COOPER NUCLEAR STATION

AMENDMENT TO FACILITY OPERATING LICENSE

Amendment No. 145  
License No. DPR-46

ATTACHMENT TO LICENSE AMENDMENT NO. 145

FIGURE 2.1.1  
REACTOR WATER LEVEL  
INDICATION CORRELATION

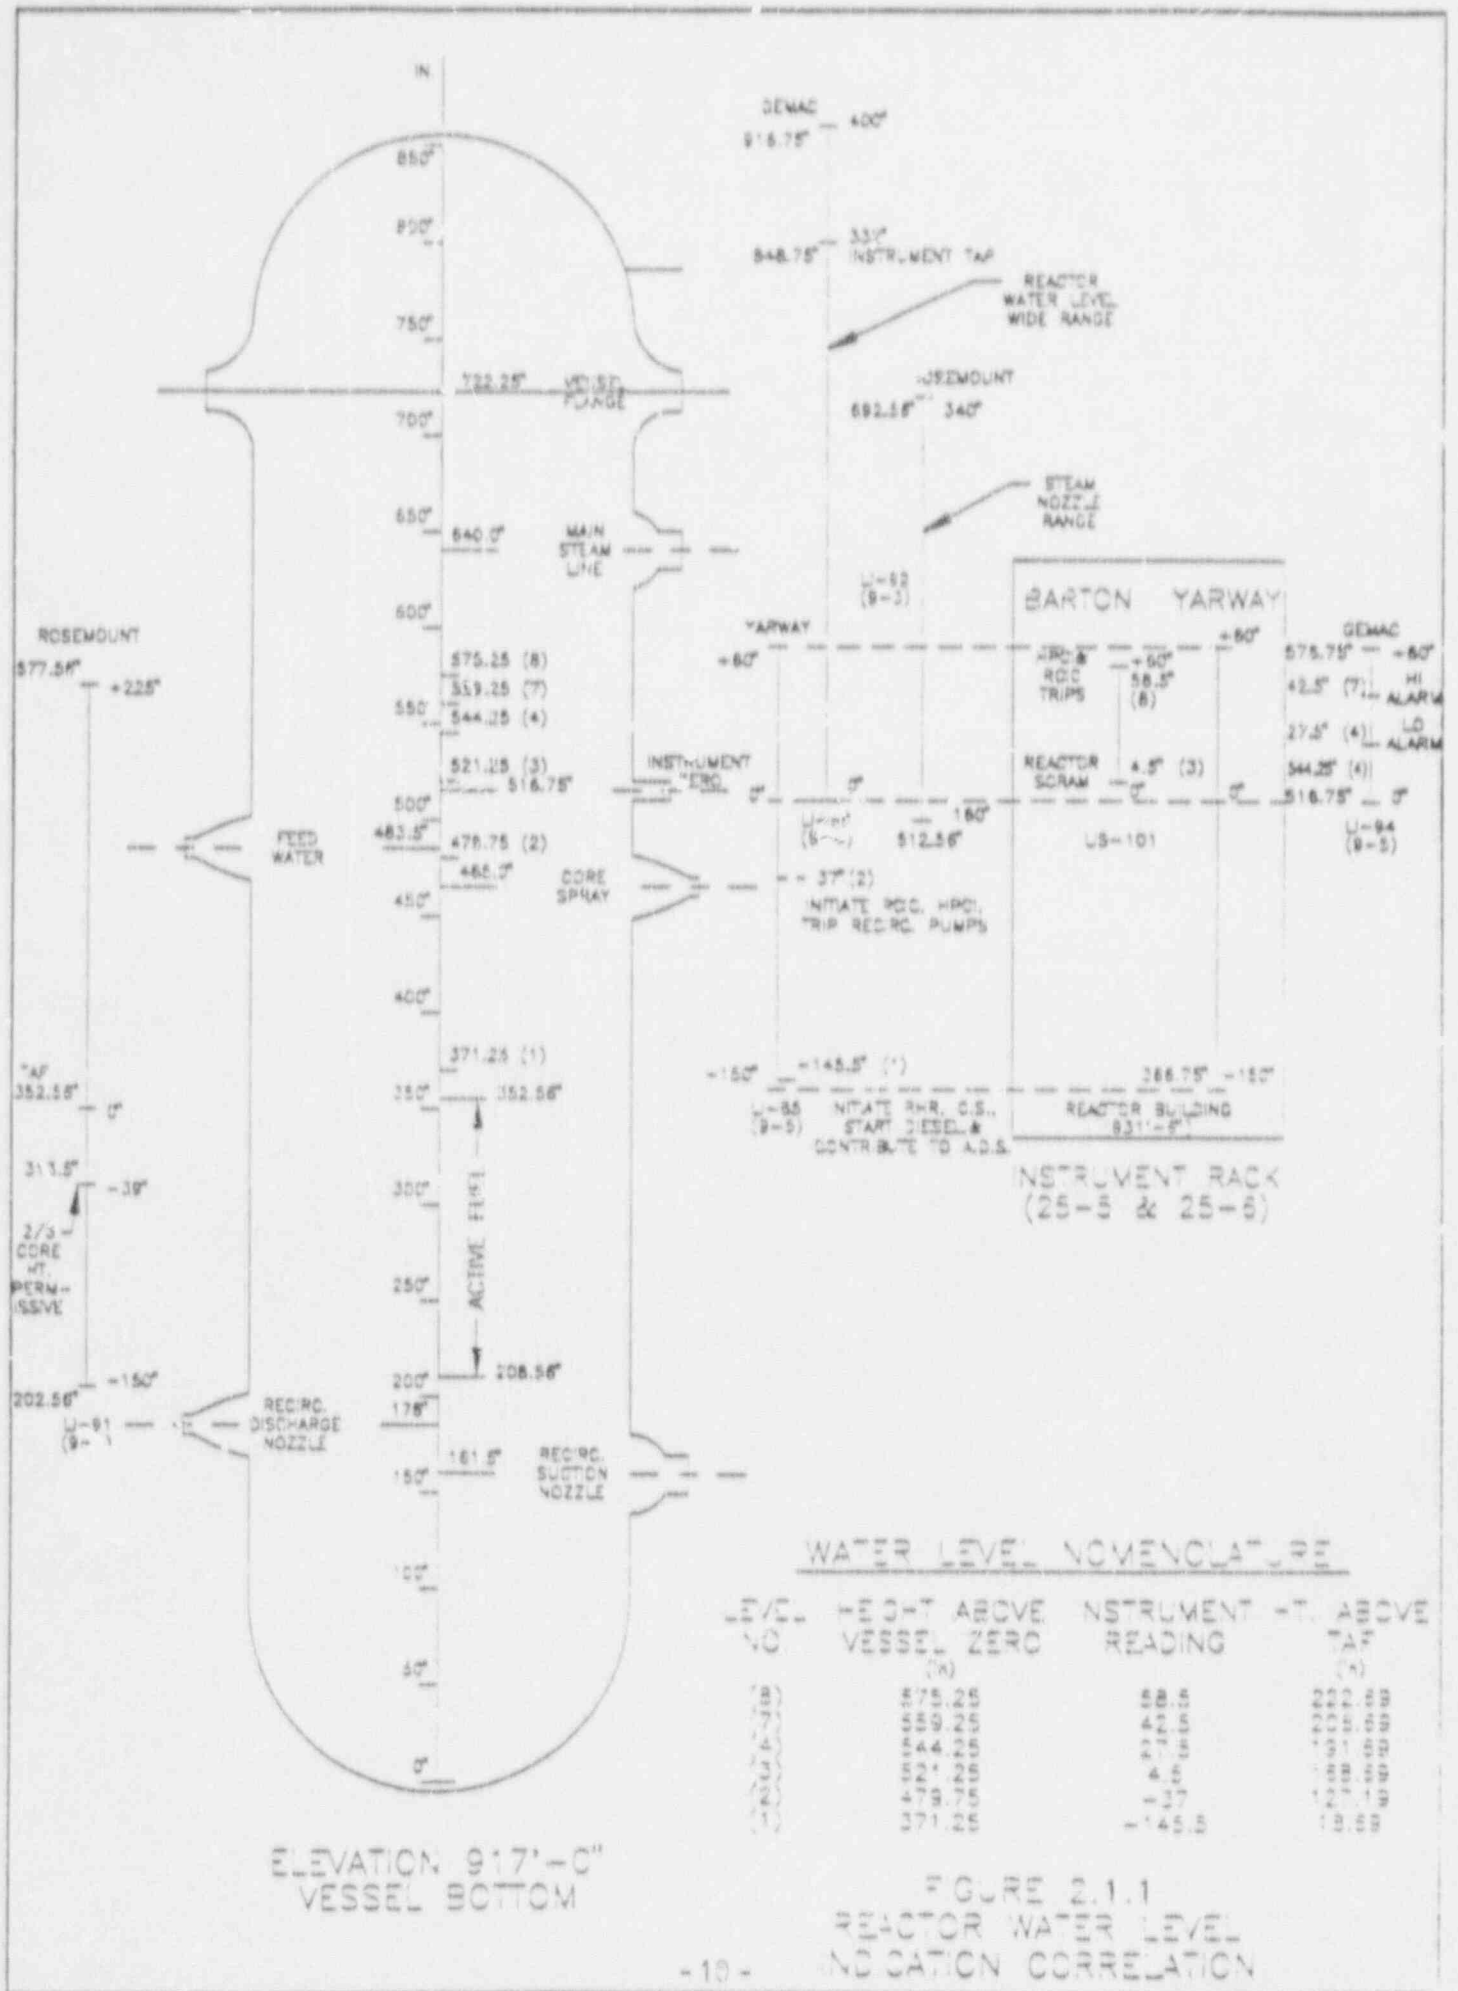
#### 2. Reactor Water Low Level Scram and Isolation Trip Setting (except NSIV)

> +4.5 in. on vessel level instruments.
